**Independent External Review of
Crane Mountain Landfill**

**Crane Mountain Enhancement,
Inc.**

**ADI Limited
Report: (85) 5668-1.1
Date: November 2005**

Monthly Leachate and Precipitation
Figure 5-8

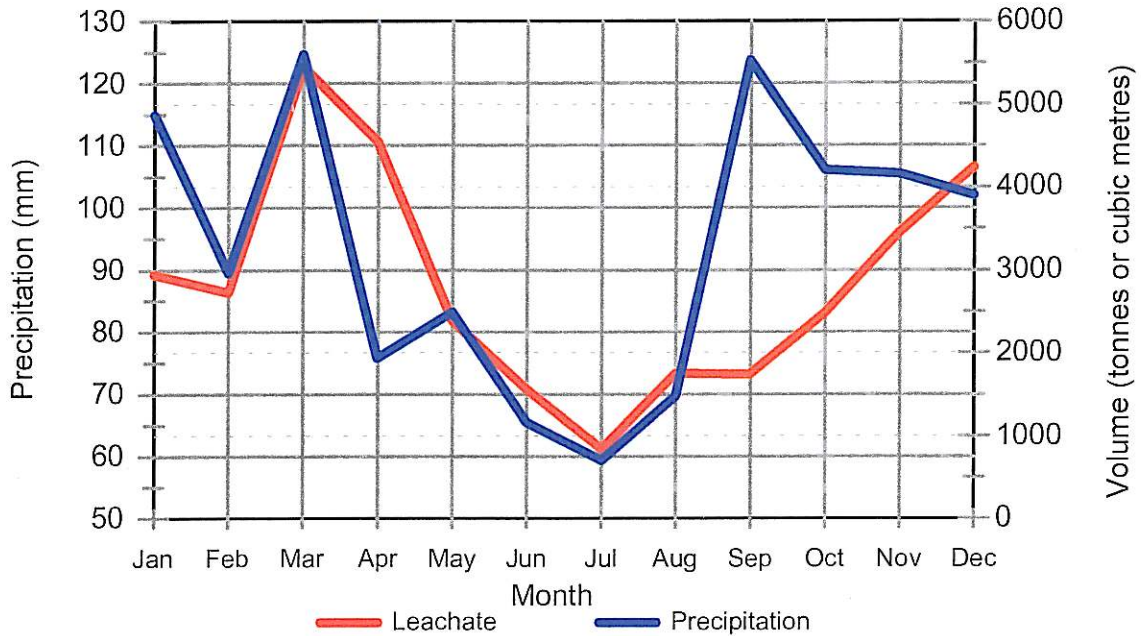
Figure 5-8 shows a plot of the monthly leachate volumes. Despite annual variations, a general pattern can be noted. Leachate flows typically peak in March, then progressively drop to a low in July, followed by an increase back to March. Also shown on Figure 5-8 is a comparison of the average monthly leachate volumes compared to the average monthly rainfall depths. There appears to be a general correlation between the rainfall and leachate volumes, with a degree of soaking up precipitation after the summer.

Project Title	
INDEPENDENT EXTERNAL REVIEW OF CRANE MOUNTAIN LANDFILL	
Dwg. Title	
SURFACE WATER MONITORING SITES	
Project No.	5668-001.1
Dwg. No.	FIGURE 6-3
Rev. No.	0
Scale	1:20000
This drawing is not to be scaled

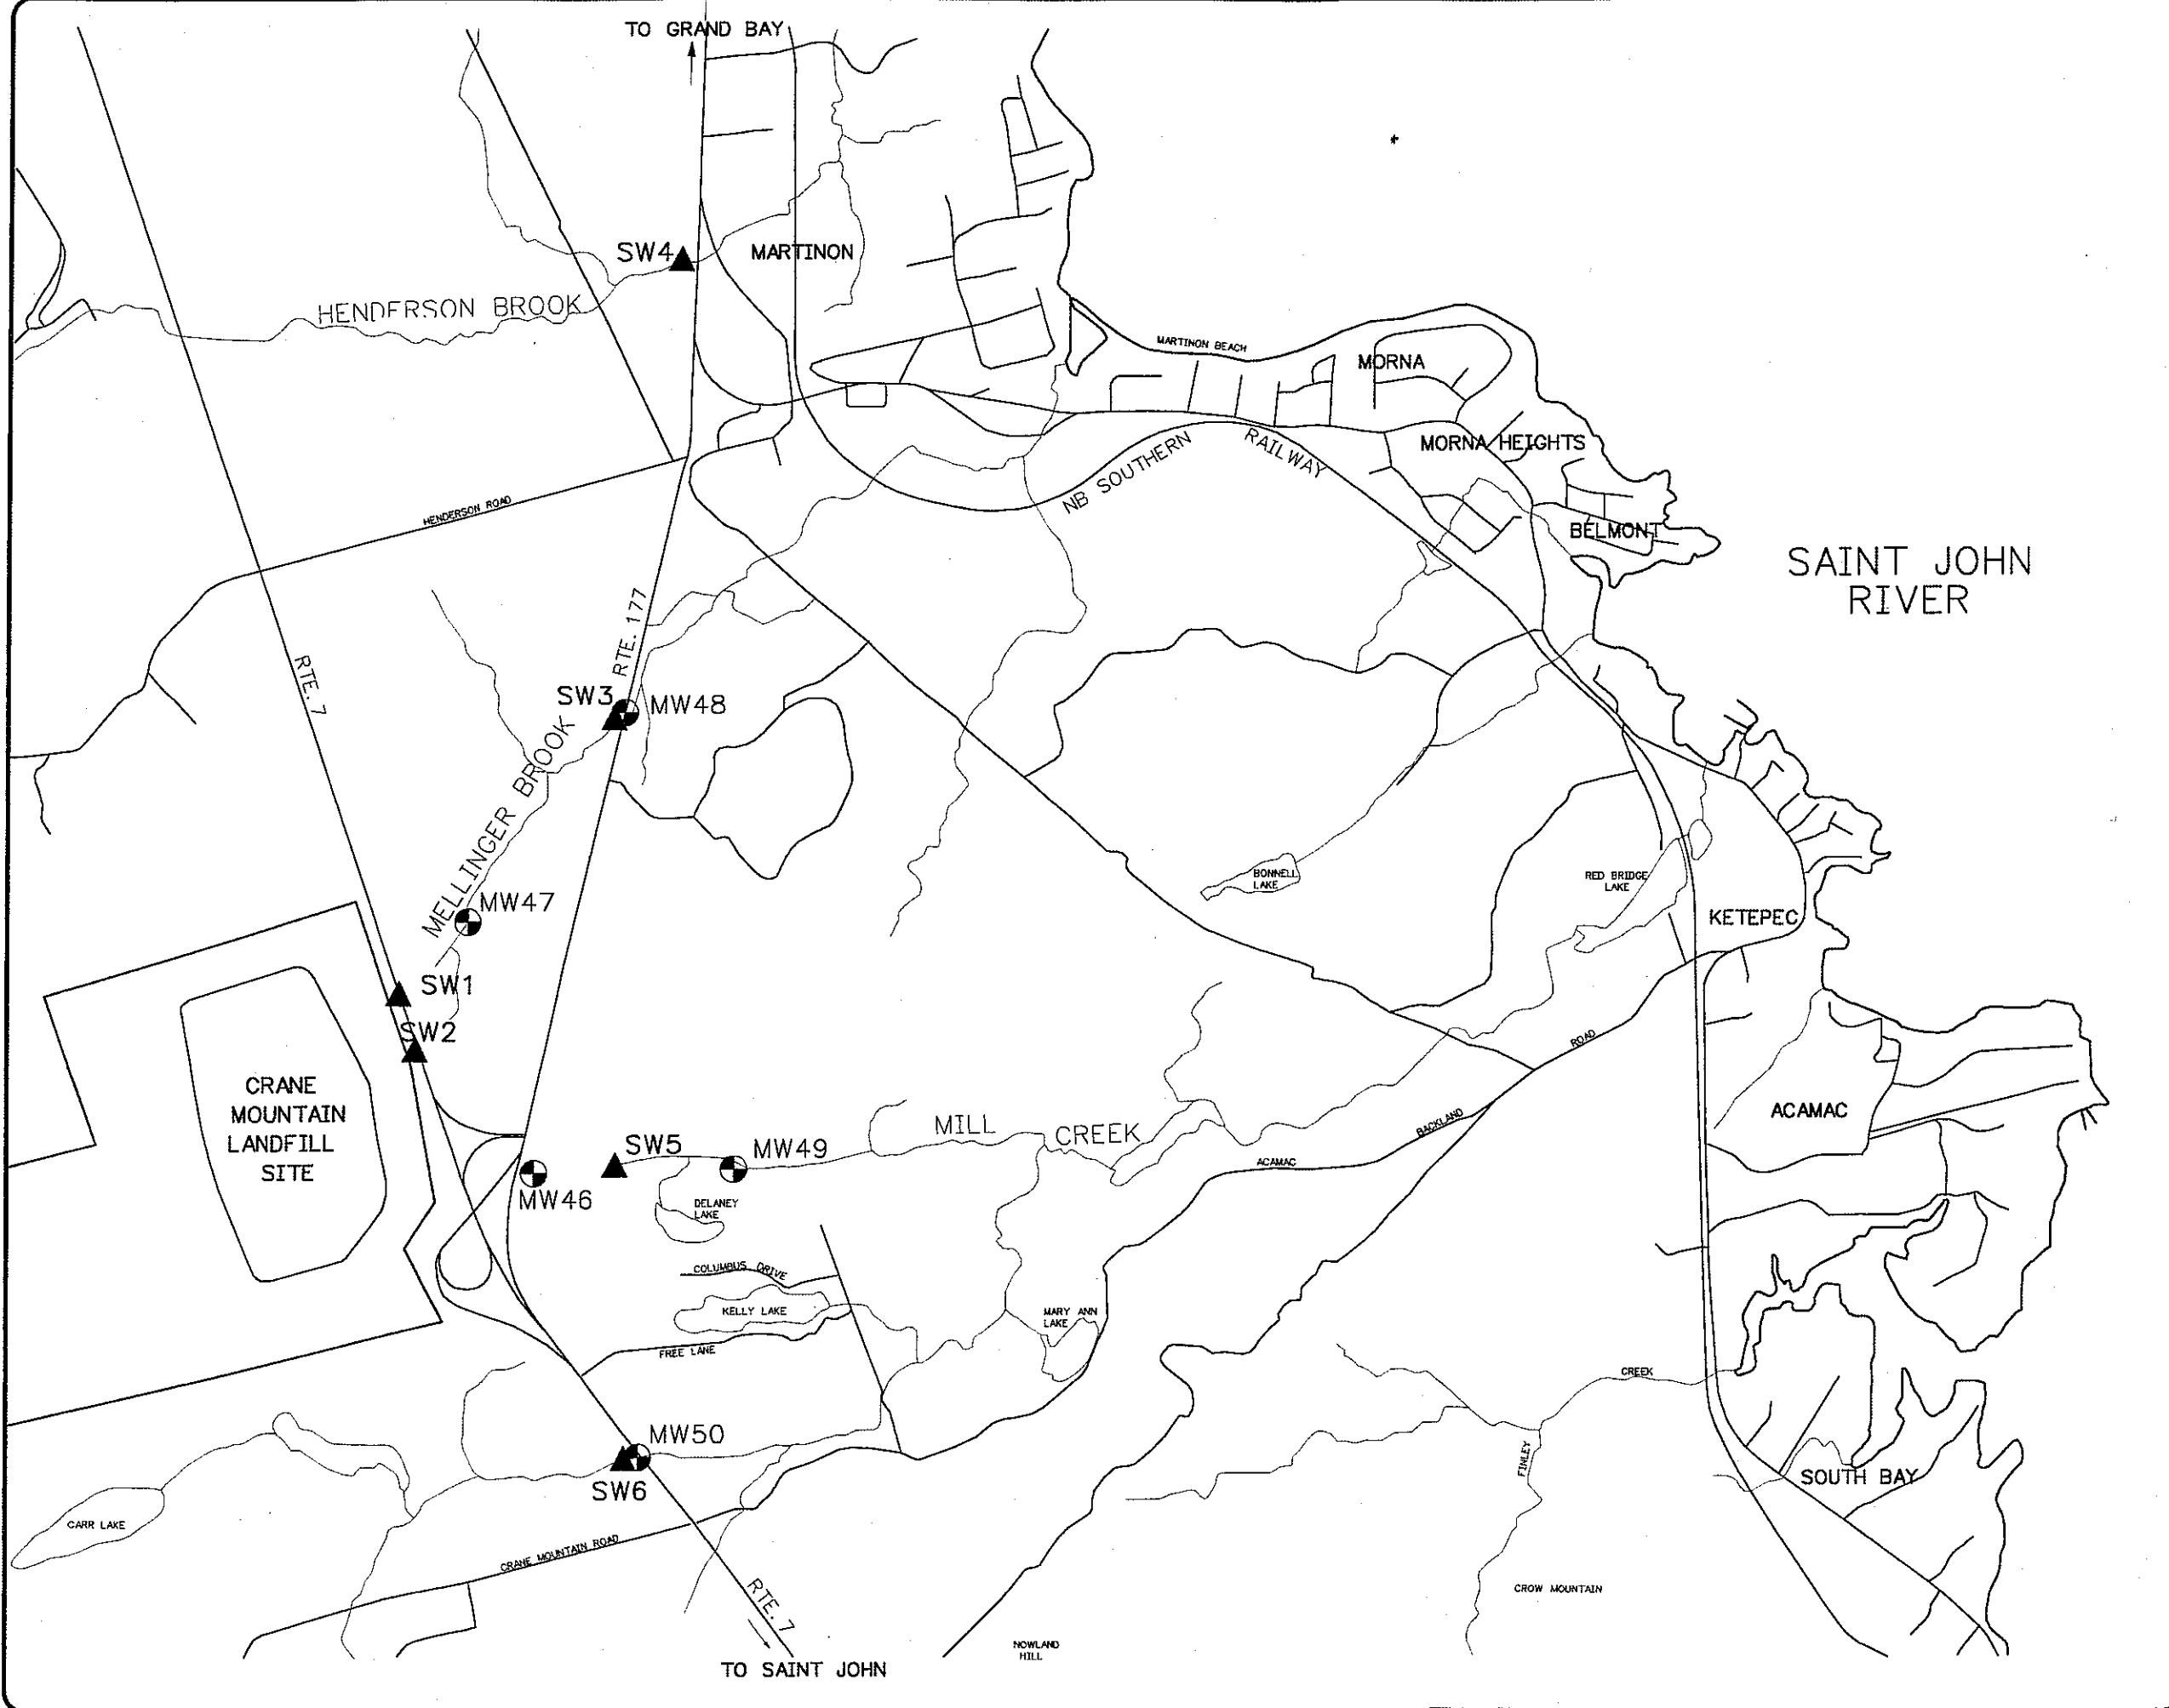
The surface water monitoring sites are shown on Figure 6-3. They include one on Henderson Brook in Martinon, three on Mellinger Brook into which the sedimentation pond discharges, and two on the Mill Creek system. The frequency of monitoring (two times per year) is considered to be the minimum acceptable. The analytical suite is considered adequate, and screens for a number of typical landfill leachate impact indicator parameters (e.g. chloride, conductivity, ammonia).
